From: "Zhen, Davis"  
To: "Young, Howard S." <younghs@cdmsmith.com>  
"Sheldrake, Sean" <sheldrake.sean@epa.gov>  
CC: "Scott Coffey" <coffeyse@cdmsmith.com>  
"Vickstrom, Kyle E." <vickstromke@cdmsmith.com>  
Date: 8/6/2018 7:35:14 AM  
Subject: RE: Multiple Core Attempts

From: Young, Howard S. [mailto:younghs@cdmsmith.com]  
Sent: Friday, August 3, 2018 2:43 PM  
To: Zhen, Davis <Zhen.Davis@epa.gov>; Sheldrake, Sean <sheldrake.sean@epa.gov>  
Cc: Scott Coffey <coffeyse@cdmsmith.com>; Vickstrom, Kyle E. <vickstromke@cdmsmith.com>  
Subject: FW: Multiple Core Attempts

Subject: Multiple Core Attempts

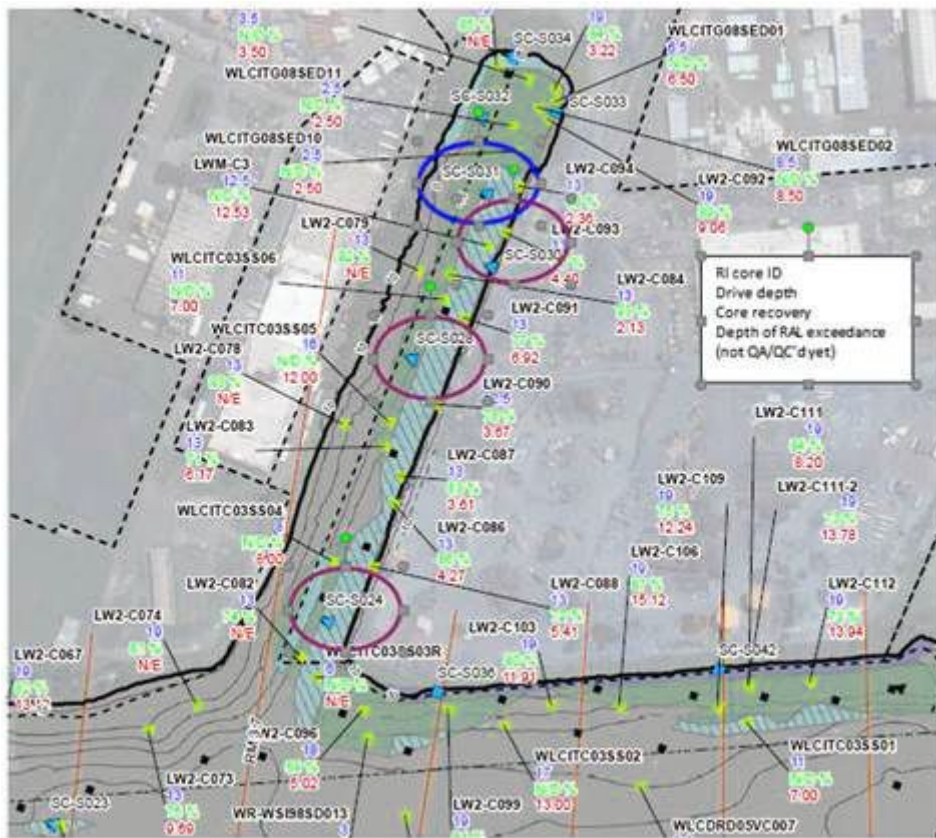
A refusal depth of 8 to 10 ft is pretty consistent with other nearby deep core locations in the slip from last week (see purple circles). In this case, we made an informed decision about site conditions observed in the field and accept the first at core location S031. Three attempts are not necessary when the refusal depths are consistent in the area. The FSP states that up to 3 attempts may be advanced if target criteria are not met. We request that EPA confirm that less than 3 attempts are necessary if we can make informed decisions about site conditions. We also request the term "refusal" be removed from criteria "e" in the FSP and that the target depth range (e.g., +/- 5 ft) be understood by the field team as acceptable if refusal is encountered shallower than the target depth. We can document these conditions in an Anomaly Notification to EPA, if desired.
